City of Portland
Bureau of Development Services
Land Use Services Division

NOTICE OF A TYPE I DECISION ON A PROPOSAL IN YOUR NEIGHBORHOOD

CASE FILE NUMBER: LU 08-134202 LDP

The applicant is proposing to divide a 9,975 square foot site into two parcels; one standard and one flag lot. The existing house will remain on Parcel 1, the standard lot, and contain approximately 4,750 square feet of site area. Parcel 2, the flag lot will be approximately 5,225 square feet and will provide a vacant building site for single family detached development. No trees on the site require preservation.

CASE NO. LU 08-134202
 EXHIBIT C1

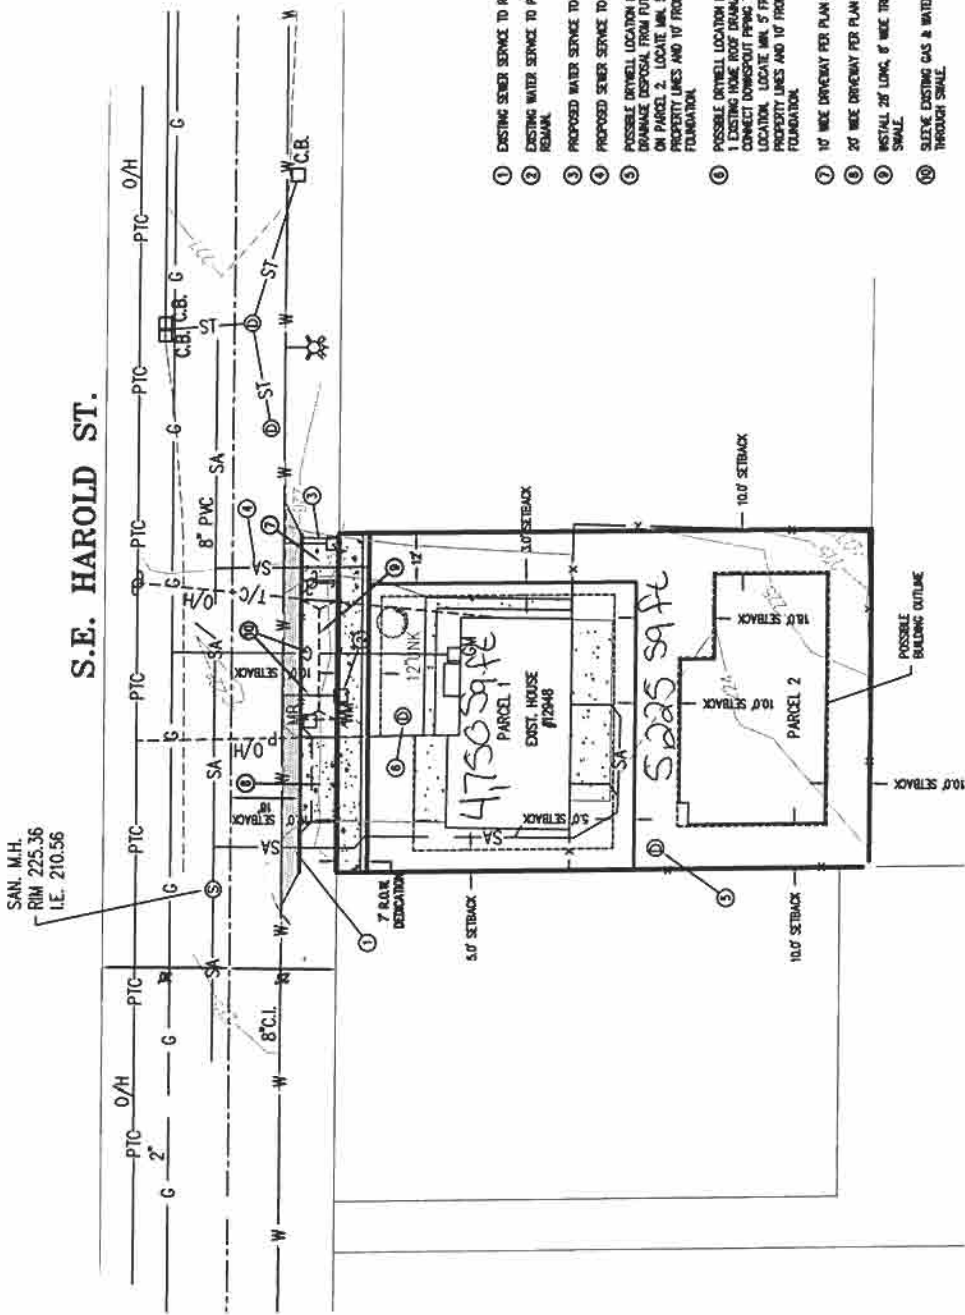
This criterion is met, with the condition that frontage improvements are made, and the required right-of-way dedication is shown on the Final Plat.

- **Parcel 1 (the lot with the existing house):** The applicant has not provided information on how stormwater disposal for the existing house is managed. The applicant must obtain final approval of a plumbing permit to install rain drains and a drywell to serve the existing house. All downspouts for the existing house must be connected to the new system.
- **Parcel 2:** Stormwater from this lot will be directed to an individual drywell that will treat the water and slowly infiltrate it into the ground. This lot has sufficient area for a stormwater facility that can be adequately sized and located to meet setback standards, and accommodate water from a reasonably sized home. Site Development has indicated approval of the drywell based on the conceptual site plan provided (Exhibit C-1). This site plan should also address BES concerns regarding this site.

- The applicant must meet the requirements of the Fire Bureau in regards to addressing requirements for the flag lot, driveway width and surfacing and, and meeting turning radius requirements onto the flag pole (25 ft. inside, 45 ft. outside). There is an existing power pole that appears to restrict access to the flag lot. If the applicant can not meet the turning radius requirement they choose to provide internal fire suppression sprinklers for new development of the flag lot. This exception requires an Acknowledgement of Special Land Use Condition, with a corresponding note on the final plat. These requirements are based on the technical standards of Title 31 and the Fire Code. See attached Exhibit E-4.

The applicant has proposed a 2-lot partition, as shown on the attached preliminary plan (Exhibit C-1). As discussed in this report, the relevant standards and approval criteria have been met, or can be met with conditions. The primary issues identified with this proposal are: street dedication & improvements, stormwater management for the street improvements, and fire bureau requirements.

1. The applicant shall meet the street dedication requirements of the City Engineer for SE Harold Street. The required right-of-way dedication must be shown on the final plat.

1. The applicant shall meet the requirements of the City Engineer for right of way improvements along the frontage of SE Harold Street. The applicant shall provide plans and stormwater analysis and financial assurances to the satisfaction of the Bureau of Transportation Engineering and Development Review and the Bureau of Environmental Services for required street frontage improvements.

2. The applicant must obtain and finalize a plumbing permit to install rain drains and a drywell to serve the existing house on Parcel 1. All downspouts for the existing house must be connected to the system.

5. The applicant must show how the Fire Bureau turning radius requirements for access to Parcel 2 will be met. Alternatively, the applicant may install residential sprinklers for new development on Parcel 2. An Acknowledgement of Special Land Use Condition must be recorded and noted on the plat if sprinklers are provided.
